Re. : Amendment and Response to Office Action Mailed September 16, 2005
Appl. No. : 10/668,747
Filed : September 23, 2003

IV. REMARKS

Fig. 2

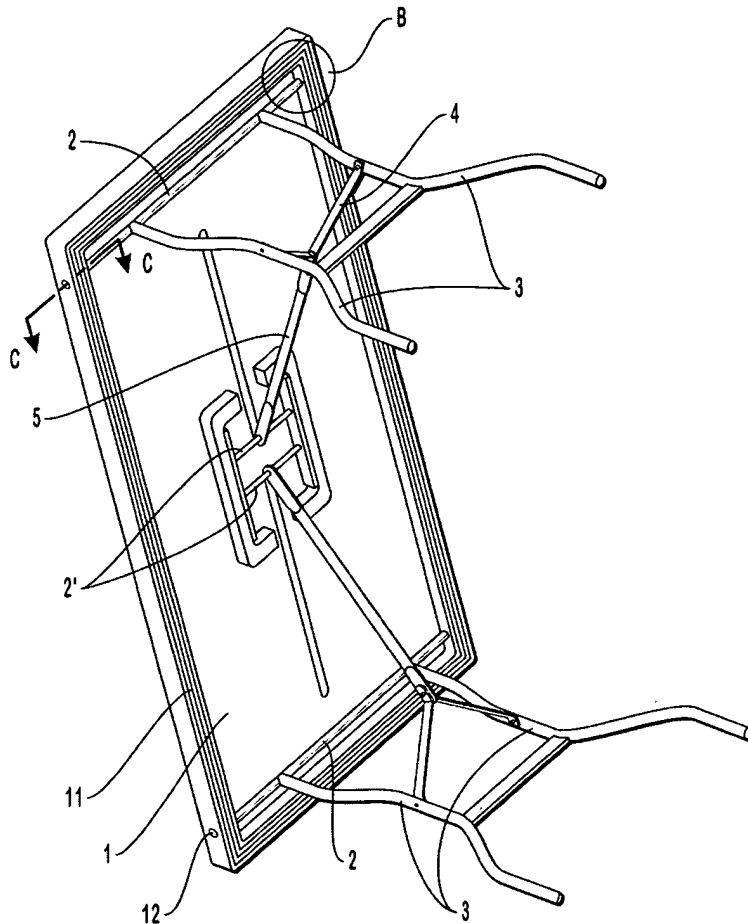
The Office Action objected to the drawings. In particular, the Office Action stated that Figure 1 should be designated by a legend such as --Prior Art--because only that which is old is illustrated. See MPEP § 608.02(g). The Office Action stated that the drawings are objected to as failing to comply with 37 CFR 1.84(p)(5) because they do not include the following reference sign(s) mentioned in the description: 22. The Office Action stated that the drawings are also objected to as failing to comply to 37 CFR 1.84(p)(5) because they include the following reference character(s) not mentioned in the description: B-3, B-4, and 2’.

As set forth above, Applicants amended the specification to conform the specification to Figure 2. In particular, Figure 2 illustrates that a center bar 2’ may be connected to a bar 5 and that the bar 5 may be connected to a strut 4:

Accordingly, Applicants amended paragraph [055] of the specification by replacing the reference 22 with the reference 2' to conform the specification to Figure 2:

[055] As shown in Figure 2, table top 1 also has two U-shaped inner lips which face each other. The interior surface of the inner lips has connecting apertures similar to those described above. **In addition, bushings or sleeves similar to those described above may be used to align an end of a center bar 2' ~~22~~ therein. The center bar 2' ~~22~~ is shown connected to an end of support bar 5. The other end of support bar 5 is connected to a V-shaped strut 4. The other end of V-shaped strut 4 is connected to a table leg 3.**

Consequently, the description now properly includes the reference 2' and no longer includes the reference 22.

Because the description no longer includes the reference 22, the drawings need not include the reference 22, and Applicants therefore request that the objection based upon the omission of the reference 22 from the drawings be withdrawn.

Further, because the description now includes the reference 2', the reference 2' need not be removed from the drawings, and Applicants therefore request that the objection based upon the inclusion of the reference 2' in the drawings be withdrawn.

Fig. 5

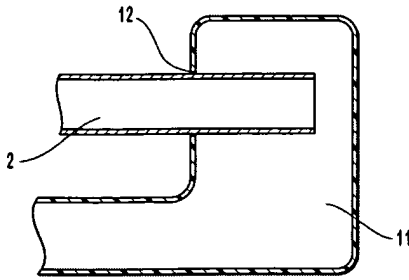
Figure 5 illustrates a cross pole 2 disposed in an aperture 12:

Fig. 4

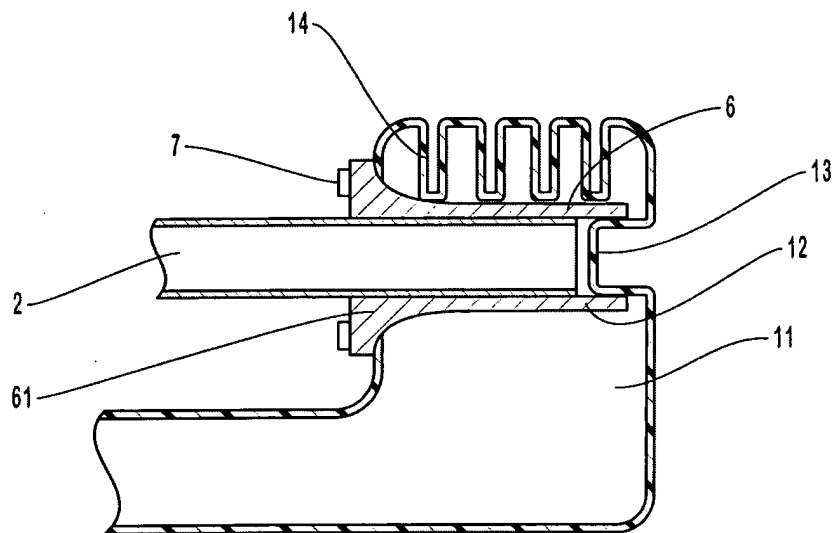
Figure 4 illustrates a plurality of grooves 14:

Fig. 2

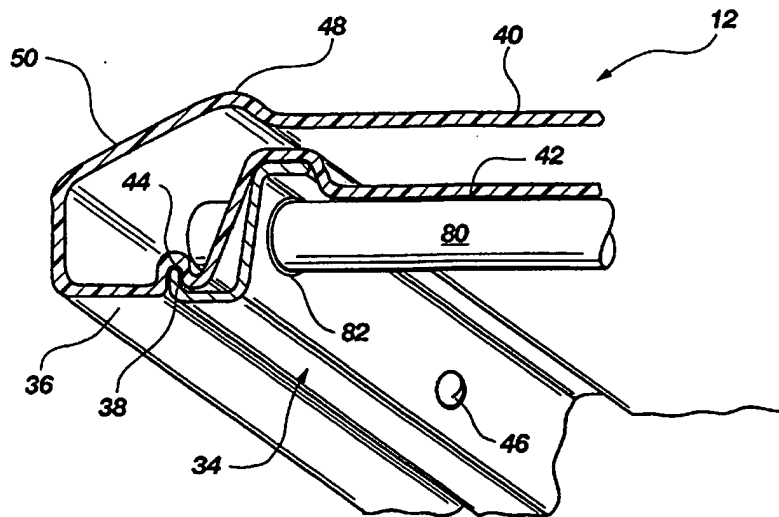
In contrast, the Nye Patent discloses that an edge of a side rail fits in a notch. For example, Figure 2 illustrates an edge of a side rail of the table top frame 34 that fits in a notch 44:

Fig. 2A

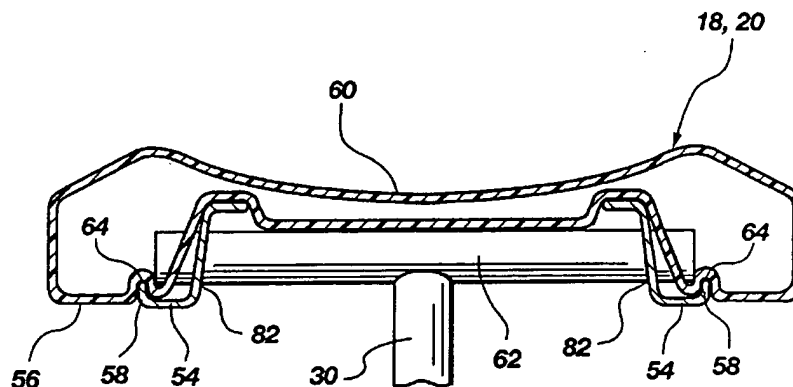
The Office Action rejected Claims 1, 3, 4, 8, 14, 16, 18 and 19 under 35 U.S.C. § 102(b) as being anticipated by U.S. Patent No. 5,921,623 issued to Nye et al. In particular, the Office Action stated that the Nye patent teaches a table (Fig. 2A) comprising: a plastic blow molded table top (12) having a lip (see depending portion of 12 in Fig. 2A and Attachment A) with interior, outer and bottom surfaces and a first connecting aperture (82) located in the interior surface; a first table leg (30); and a first cross pole (62) attached to a first end of the table leg and disposed in the first connecting aperture. The Office Action states that the lip also includes a groove/recess (64). The Office action states that, since the Nye patent teaches all of the structural limitations found in the method claims, the method steps would be inherently provided for.

In addition, as shown in Figure 3, an edge of a side rail of the bench frame 54 fits in a notch 64:

Figure 1
(Prior Art)

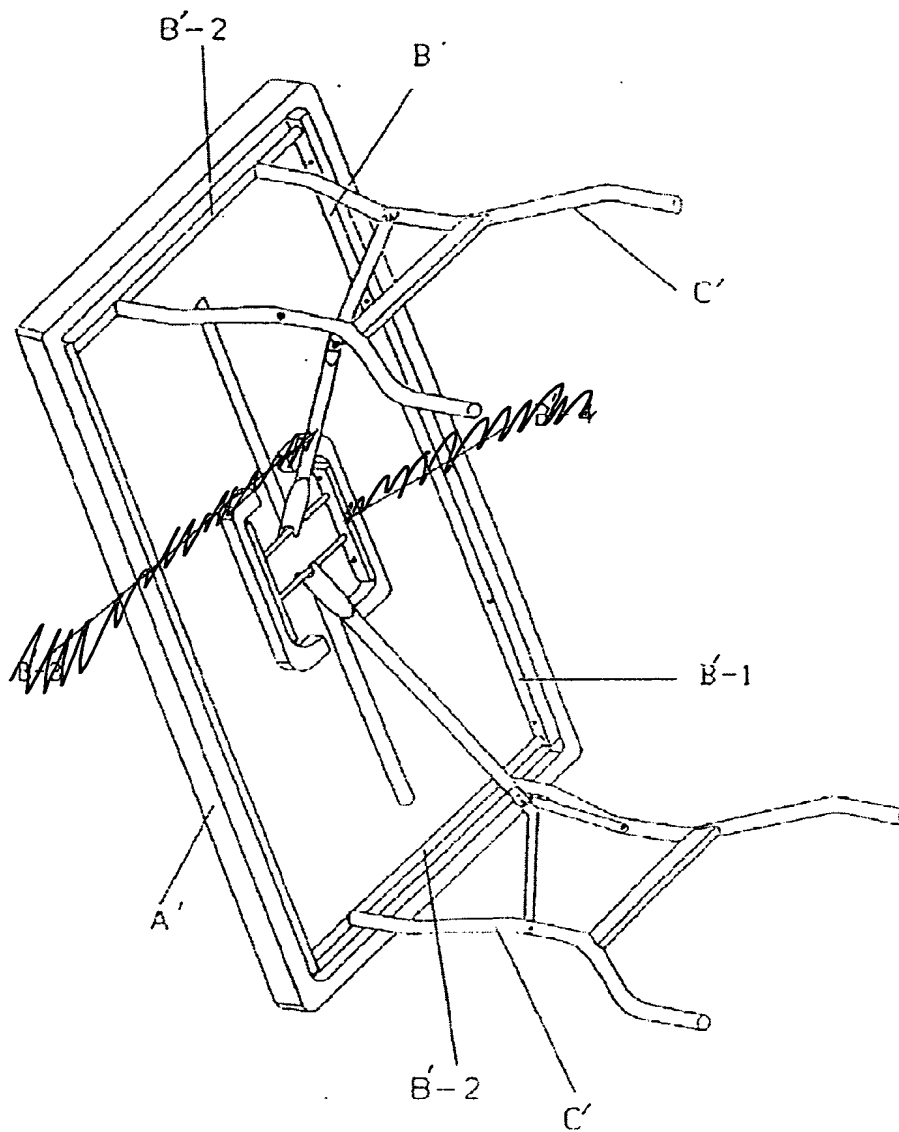
The attached replacement sheets of drawings are formal drawings to replace the drawings originally filed. The attached replacement sheets of drawings also include an amendment to Figure 1 that adds the legend "PRIOR ART" to Figure 1 and removes references B'-3 and B'-4. These attached replacement sheets of drawings, which include Figures 1-6, replace the original sheets of drawings which included Figures 1-6.

An annotated or marked-up sheet of drawings for Figure 1 is also attached. The annotated sheet of drawings shows the proposed drawing corrections in red ink.

As set forth above, Applicants amended Figure 1 to include the “Prior Art” legend and therefore request that the objection based upon the omission of the “Prior Art” from the drawings be withdrawn.

Applicants amended Figure 1 to remove the references B’-3, B’-4 and therefore request that the objections based upon the inclusion of the references B’-3, B’-4 in the drawings be withdrawn.
